| Consultant | Wahib Medanat Consultant Engineer | Rep No. | 11-19022022 |
| Contractor | Derar Saraireh & Sons for Engineering & Contracting | Tender No. | (11/2019/USAID/SKEP/3/S) Schools for a Knowledge Economy Project (SKEP) - Phase (3) Package (1, 2) |
| Site Name | Um Al Dananir Basic Mixed School- Al Balqa | Day/ Date | Sat. 19/02/2022 |

Visit Notes

(figure:13 & 14)

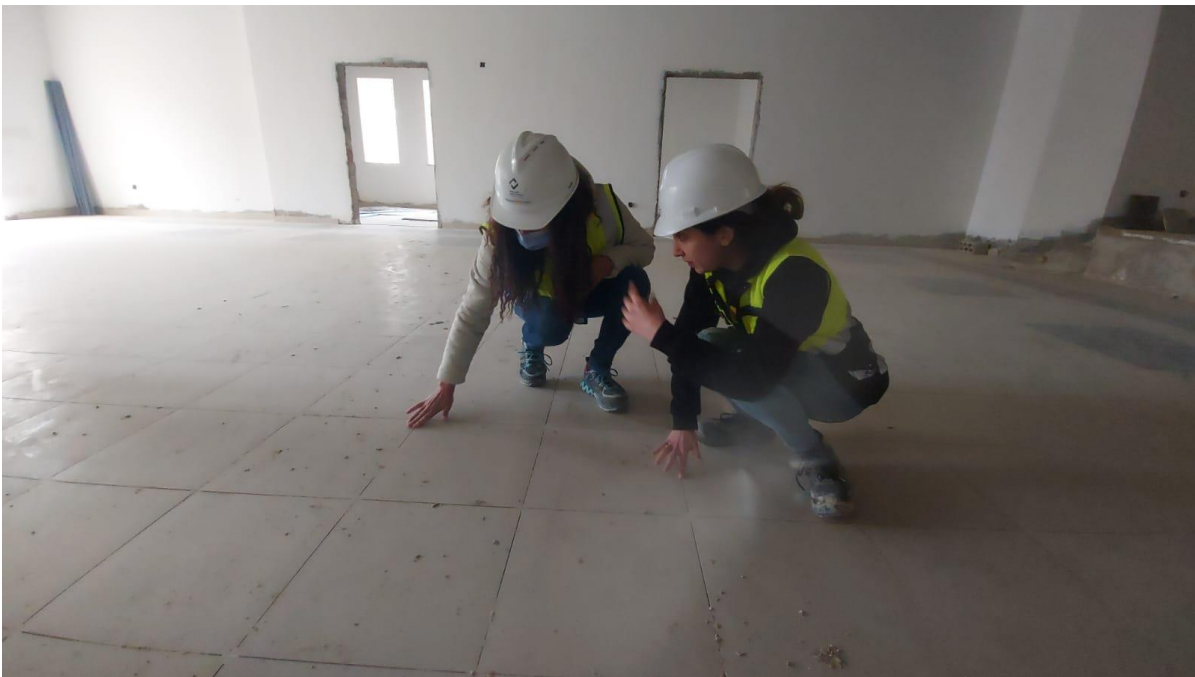
The team discussed with the Contractor the connection of floor porcelain tiles of two corridors. The Contractor suggested to install a granite piece at the connection line
